Creak/Chirp Noise From Rear Of Vehicle
On Rough/Uneven Surfaces –
Parking Brake Cables – Repair Procedure

MODEL 2002 MY-ON
X-TYPE

VIN C00294-E45113

ILLUSTRATION 3

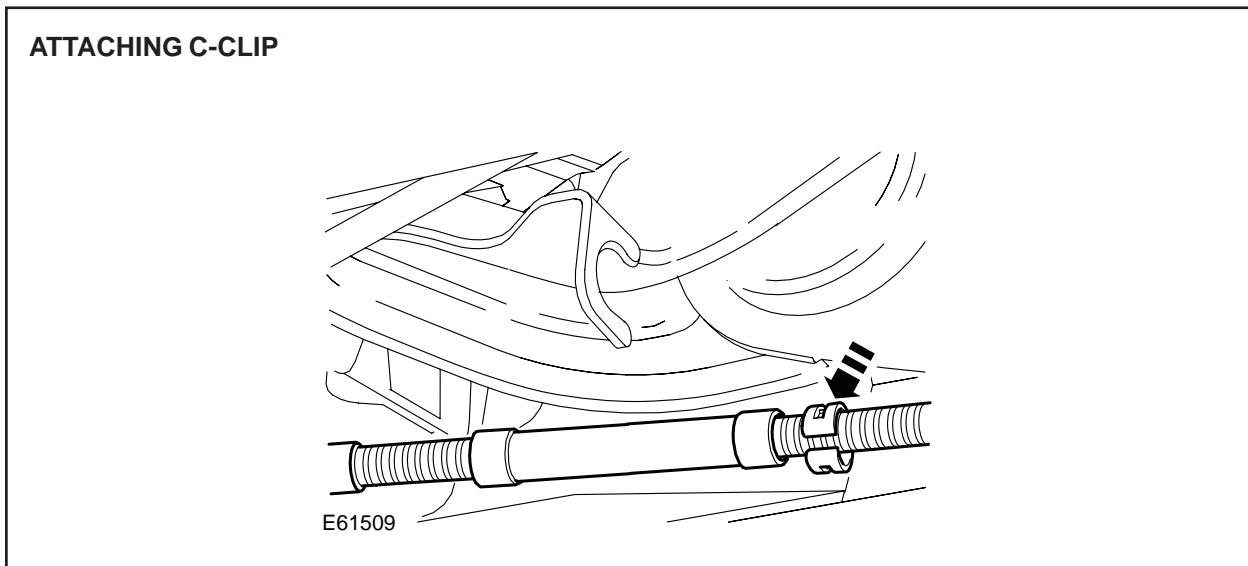
If the parking brake cable is under 12.5 mm, install new modified C-clips on the parking brake cables. Follow the Service Instruction outlined below.

4. Install the new C-clip to the rear parking brake cable (Illustration 3).

ILLUSTRATION 4

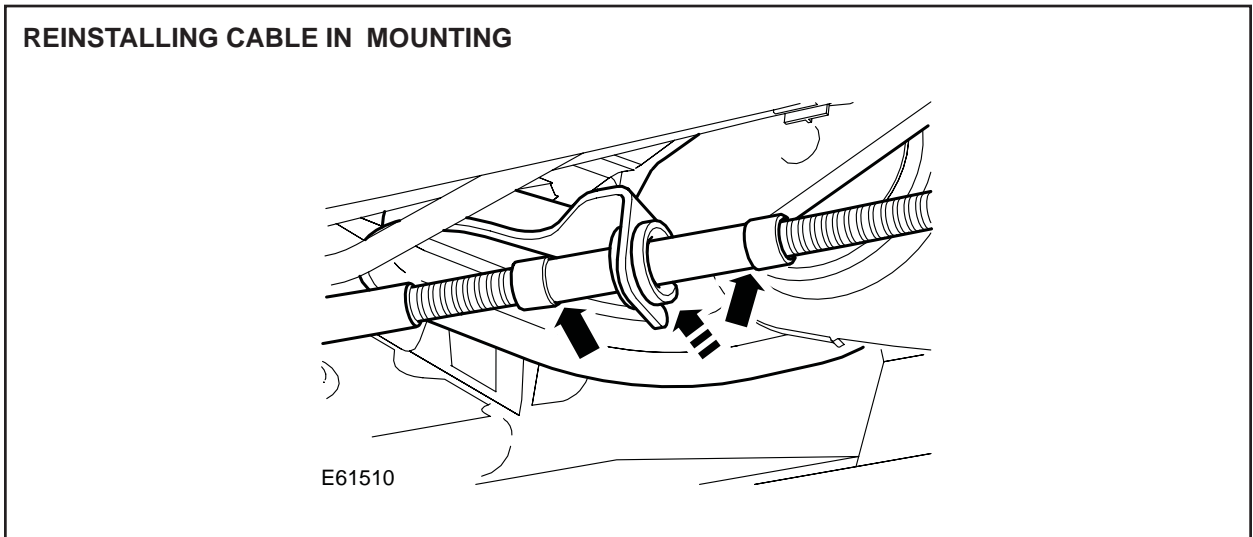
5. Install the rear parking brake cable to the mounting, ensuring the C-clip is in the centre of the crimps (Illustration 4).
